# Seemingly simple

The Glitch:

➢ **Figure 1**

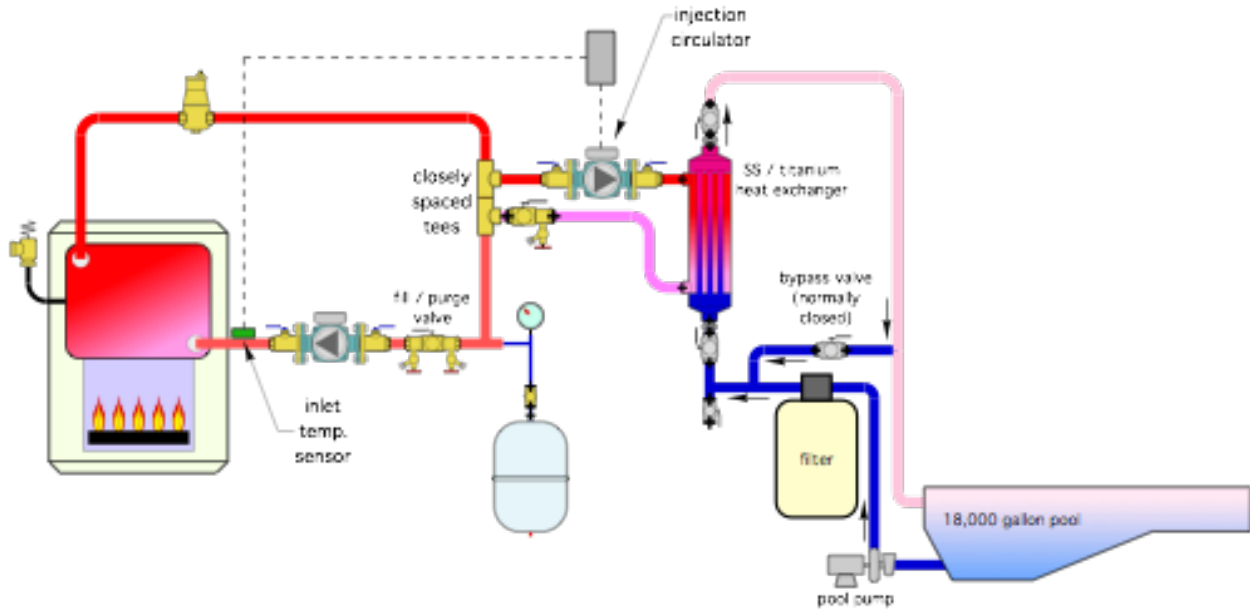
A homeowner hires a heating contractor to upgrade his propane-fired cast-iron boiler to a mod/con boiler. The cast-iron boiler is only 15 years old and in good shape. The homeowner asks if the contractor can reuse it to add heat to his 18,000 gallon in-ground swimming pool. The installer knows that this is possible using a heat exchanger. The installer also knows that the relatively cool pool water could cause sustained flue gas condensation in the boiler, and therefor decides to use a "bypass loop" with a separate circulator as shown in Figure 1. Because the repurposed boiler will be located in the pool house, the entire system up to and including the primary side of the heat exchanger is filled with 50% propylene glycol antifreeze. Can you spot several details that will lead to problems in this layout?

Whenever a conventional boiler (e.g, one that's not intended to operate with sustained flue gas condensation) supplies a low temperature/high thermal mass load, that boiler needs "anti-condensation" detailing.

Although one might consider the brazed plate heat exchanger as having low thermal mass, it's just interface for the thermal mass of 18,000 gallons of cold water in the pool. It's there because chlorinated pool water would otherwise quickly corrode the cast-iron boiler.

A "bypass circulator" will not protect the boiler from sustained flue gas condensation. It has no way of "understanding" when the rate of heat transfer at the heat exchanger is greater than the rate of heat production at the boiler. Whenever the heat exchanger is transferring heat faster than the boiler is producing it, the fluid temperature between the two decreases. The larger the heat exchanger is, the more the fluid temperature will drop. It is very possible that the piping design shown in Figure 1 could keep the cast-iron boil in condensing mode whenever it operates, ultimately destroying the boiler and its venting system by corrosion.

There are several other details in Figure 1 that should be changed:

1. Don't assume that any stainless steel heat exchanger can be used with pool water. High concentrations of chlorine or other disinfectants can corrode 300-series stainless steel. Use a heat exchanger that's specifically designed for pool heating. Some will use titanium, or alloys of stainless steel and titanium, for portions of the heat exchanger that contact pool water;

2. The heat exchanger in Figure 1 is piped for co-current flow (e.g., both fluid streams passing through in the same direction). This is not optimal in terms of creating the highest possible temperature difference between the two fluids. To achieve the highest temperature difference the two fluids should pass through the heat exchanger in opposite directions. This is called "counter-current" flow. It's how the heat exchanger in Figure 2 is configured;

3. I also suggest installing a bypass pipe that could route pool water around the heat exchanger if ever necessary. Any isolation, drain, or bypass valves and fittings should be PVC, CPVC, or other materials specifically rated for use with pool water;

4. The original layout lacks a pressure relief valve on the boiler, as well as an air separator and expansion tank. These have been added in Figure 2;

5. Move the fill/purge valve so that it can also serve as a low point boiler drain; and
6. Add a purge valve on the heat exchanger circuit to expedite air removal from the heat exchanger, and allow its primary side to be isolated if ever necessary.

The solution is a variable speed circulator operating in "setpoint" mode installed between the boiler loop and heat exchanger as shown in Figure 2.

For the system shown in Figure 2, the injection circulator would remain off until the boiler inlet temperature reached 130° F. It would then gradually speed up as the boiler inlet temperature continued to rise, reaching full speed when that temperature climbed to 135° or higher. This provides a "thermal clutch" between the boiler and load. It allows the full output of the boiler to reach the load, but doesn't allow the load to extract heat faster than the boiler can produce it.
